Re: Order SWD-225 – Disposal Tubing Diameter

Gallegos Canyon Unit Well No. 307 (API 30-045-24248)
1455 FSL, 510 FWL, Unit letter L, Sec 30, T29N, R12W, NMPM, San Juan County
Injection into the Mesaverde formation, Depths: 2785 to 3500

RE: GCU 307
Order No. SWD 225 May 21, 1980
30-045-24248
Section 30 29N & 12W

Current Wellbore Diagram

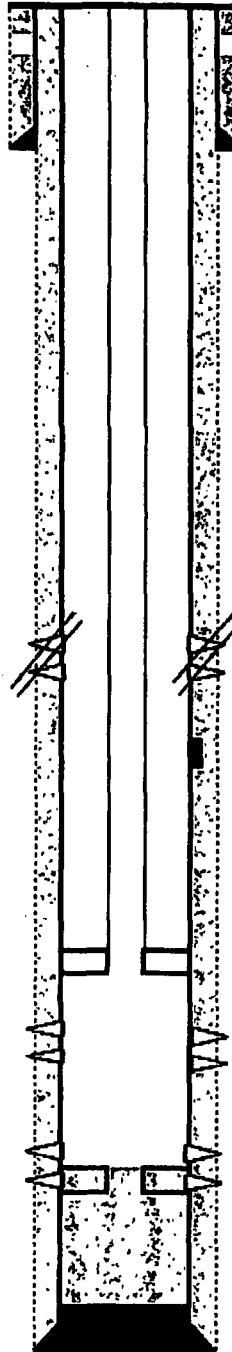
Cherry, the disposal permit SWD-225 says "approximately 2950 to 3600 feet" in the Mesaverde.
This well seems to be perforated 2785 to 2886 and also 2952 to 3500 feet – so it seems the interval from 2785 to 2886 was added as an afterthought.
Would you please look at this... Was there any permit amendment saying that upper interval could be added?

There is an approved "Modification of SWD 225". In orders under 30-045-24248; top row, 3rd document's last page. You will see the perfs 2785-2886 approved
. I'll scan and send to you if you can't find it.

Gallegos Canyon Unit 307

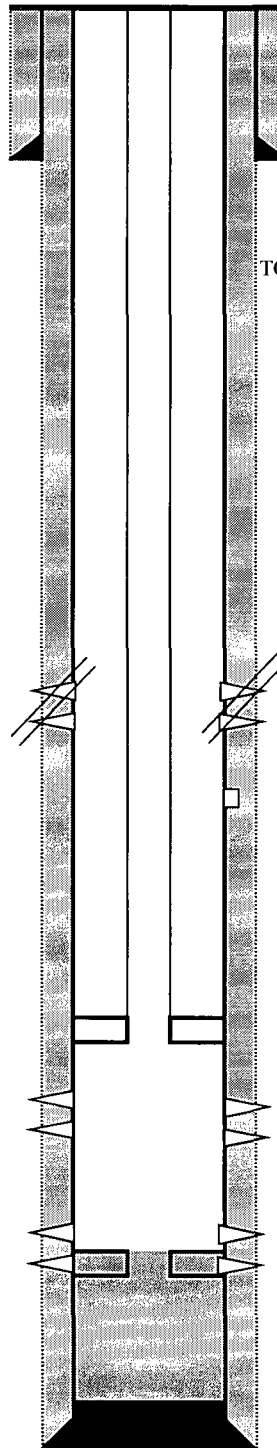
BP respectfully requests permission to change the tubing size from 2 3/8" to 2 7/8" in order to reduce injection friction pressure.

After talking to the engineer there is no reason the packer can't be set 50' above the top MV perf. Please see attached wellbore diagram.
